Access Compliance Report

Public Rights-of-Way

(Curb Ramps)

Intersection ID: 53487	Main Street: SOUTHMORE_DR	Cross Street: MATTHEWS_FARM_LN	Location: SE
ADA ID: 128E8F21840D	Ramp Type: Directional1	Initial Pass/Fail: Fail	Overall Compliance: No
		Severity Score: 1.25

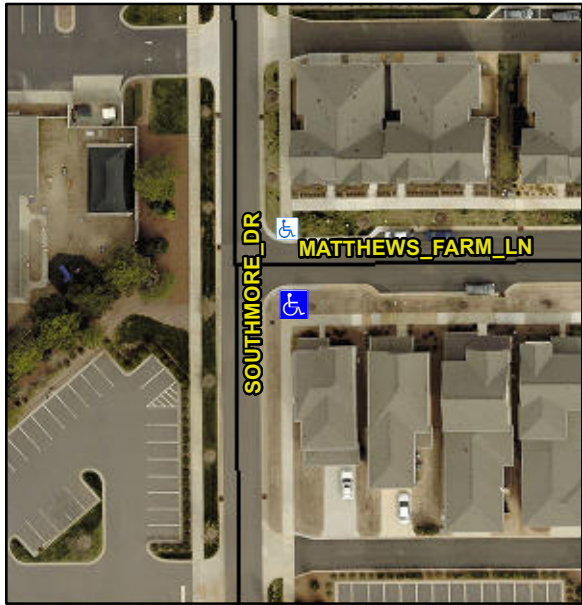
Codes/Mitigation Info/Possible Solution			Field Measurements/Component Compliance					
	Possible Solutions:		Compliance	Description	Data	Compliance	Description	Data
	Remove & Replace Entire Ramp.		N/A	Ramp Length (in)	156.0	N/A	Grade Break?	N/A
			Yes	Ramp Width (in)	71.0	N/A	Grade Break Slope (%)	0.0
			Yes	Ramp Slope (%)	7.4	N/A	Grade Break XSlope (%)	0.0
			No	Ramp XSlope (%)	2.4			
			N/A	Flare Type LT	N/A	N/A	Flare Type RT	N/A
			N/A	Flare Slope LT (%)	N/A	N/A	Flare Slope RT (%)	0.0
			N/A	Flare Traversable LT?	N/A	N/A	Flare Traversable RT?	N/A
			N/A	Landing Length (in)	0.0	N/A	DWS Provided?	N/A
			N/A	Landing Width (in)	0.0	N/A	DWS Contrast?	N/A
Surveyor Notes:		N/A	N/A	Landing Slope (%)	0.0	N/A	DWS Length (in)	N/A
PROW/ADA:		R304.5.3	N/A	Landing X Slope (%)	0.0	N/A	DWS Full Width?	N/A
			N/A	Landing Curb? (Y/N)	N/A	N/A	DWS Offset LT (in)	N/A
			N/A	Shared Landing?	N/A	N/A	DWS Offset RT (in)	N/A

N/A	Gutter Ponding?	0.0	N/A	Gutter Slope (%)	N/A
			N/A	Gutter Lip Ht (in)	0.0	N/A	Gutter X Slope (%)	N/A
			N/A	Painted X Walk1?	No		Road Slope (%)	0.2
				X Walk 1 Direction	To N		Road X Slope (%)	3.2
				X Walk 1 Width (in)	N/A		Clear Space?	N/A
				X Walk 1 Slope (%)	0.2	N/A	Clear Space to XWalk (in)	N/A
				X Walk 1 X Slope (%)	3.2	N/A	Storm Grate/Utility Hazard?	N/A
			N/A	Ramp inside XWalk1?	N/A		Storm Grate/Utility Type	
			N/A	Any Obstructions?	N/A			N/A
				Obstruction Type		Yes	Surface Condition? (G/P)	Good
					N/A	N/A	Curb Slope (%)	6.1
Street 1 Name		MATTHEWS FARM LN						
Stop Condition-Street 1		StopSign						
Street 2 Name		N/A						
Stop Condition-Street 2		N/A						
Total Cost:		\$ 1600.00
